# DEVELOPMENT REVIEW COMMITTEE (DRC) COMMENT REPORT

**PROJECT NAME:** Ferrari Maserati Building Addition

CASE NUMBER: R18036

Site Plan Level II Review: 6,628 Square Foot

# Existing Stormwater Asset Map possibly affected by the Proposed Development

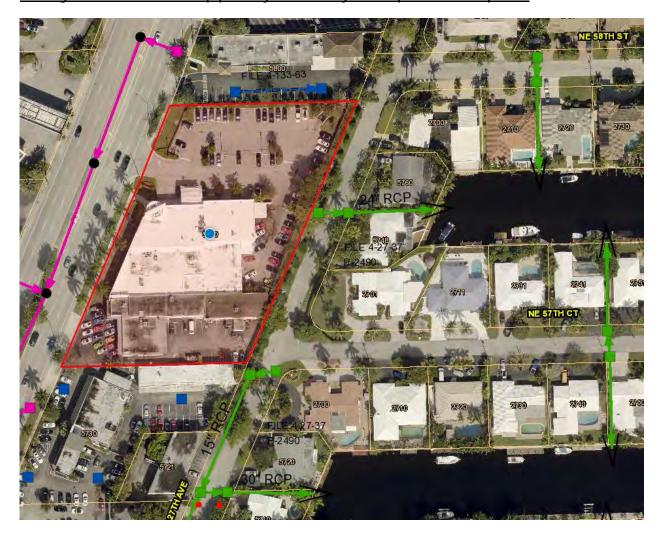
The City owns and maintains stormwater infrastructure adjacent to the proposed development as shown with green line work in the map provided at the end of this report AND green swales providing stormwater water treatment. The following comments pertain to possible impacts of the proposed development and/or construction activities to the existing condition of the City's stormwater assets. The applicant shall provide an itemized response letter addressing the following comments:

- a) Contractor shall provide CCTV videotapes to City STW OPS of the existing stormwater system to the limits shown with green line work in the storm map provided at the end of this report in order to document the PRE and POST construction conditions of the City's storm system.
